**SPECIAL MANAGEMENT AREA ORDINANCE
CHAPTER 343, HRS
Environmental Assessment/Determination
Negative Declaration**

Recorded Owner : Mae E. Parish
Applicant : Mae E. Parish
Agent : Randall I. Morikawa
Location : 91-031 Parish Drive, Ewa Beach, Oahu
Tax Map Key : 9-1-7: 2
Request : To construct a 75-foot-long, 1V:2H slope
rubblemound revetment
Determination : A Negative Declaration Is Issued

COASTAL ENGINEERING EVALUATION
AND ENVIRONMENTAL ASSESSMENT
FOR A SEAWALL
AT EWA BEACH, OAHU, HAWAII
(TMK: 9-1-07:2)

FINAL
JANUARY 1993
(Agency comments attached)

Figure 4: Proposed Revetment Typical Section

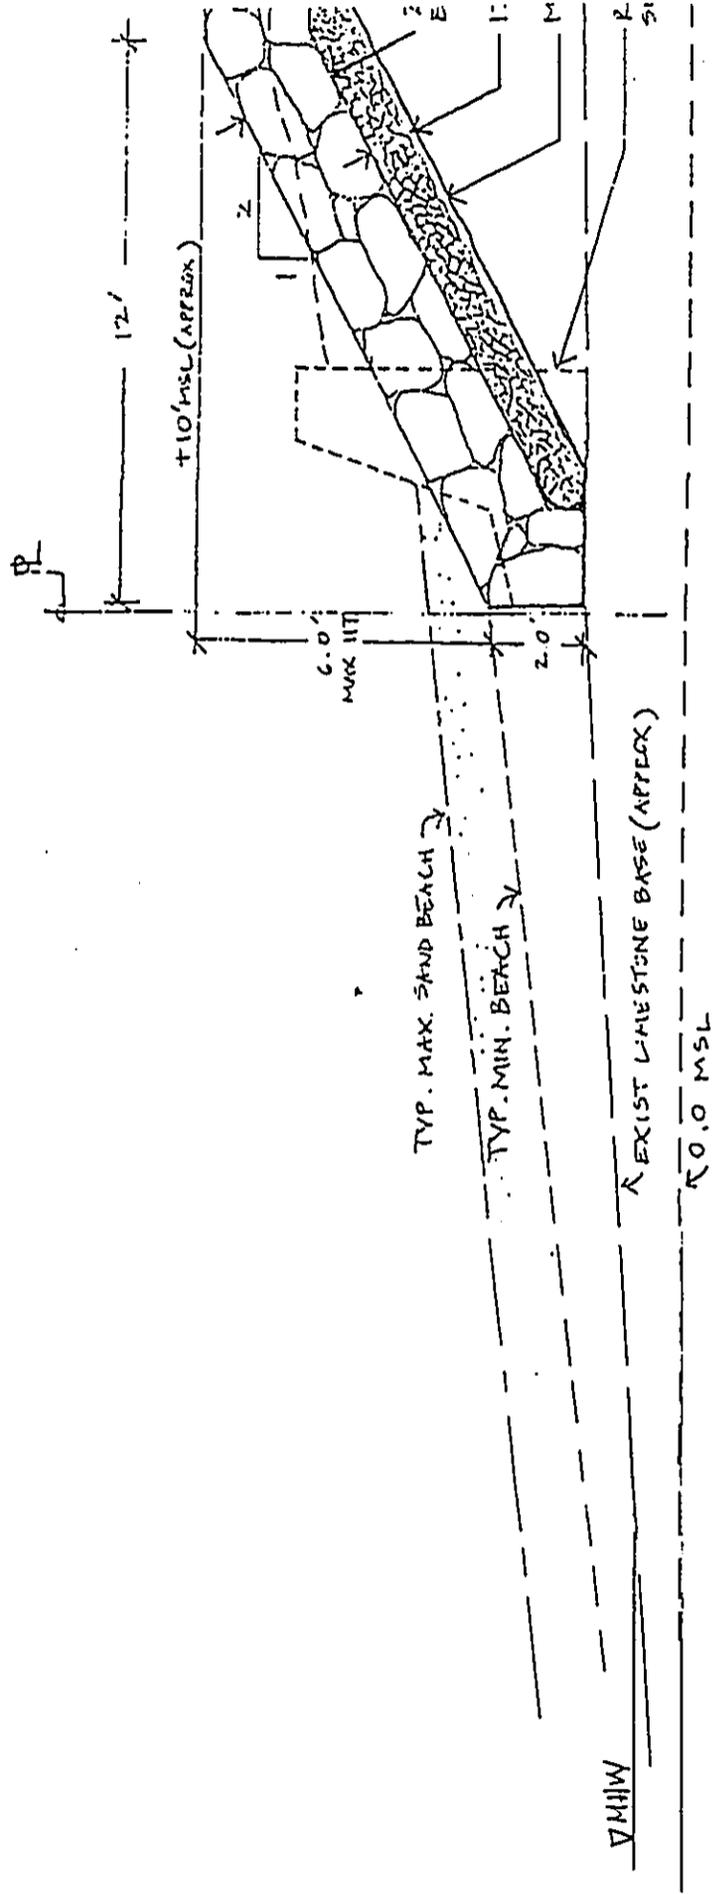
Based on the Proposed Revetment Typical Section that was faxed on October 26, 1992, the mean high water level intersects the existing limestone base approximately twenty feet from the face of the seawall's footing. Upon further review, no work will be done below the high tide mark; therefore, a Department of the Army (DA) permit is not required for the subject project.

Per our discussion this day, attached is the sketch of the proposed revetment showing the mean high water line seaward of the existing wall. The sketch¹ had to be extended seaward in order to show the approximate location of the MHW plane where it intersects the existing limestone base foundation. The existing wall rests on the limestone base, which is above the MHW plane at that location. The proposed revetment will be constructed entirely landward of the existing wall, as shown on the sketch. Therefore the revetment will be located landward of the MHW line.
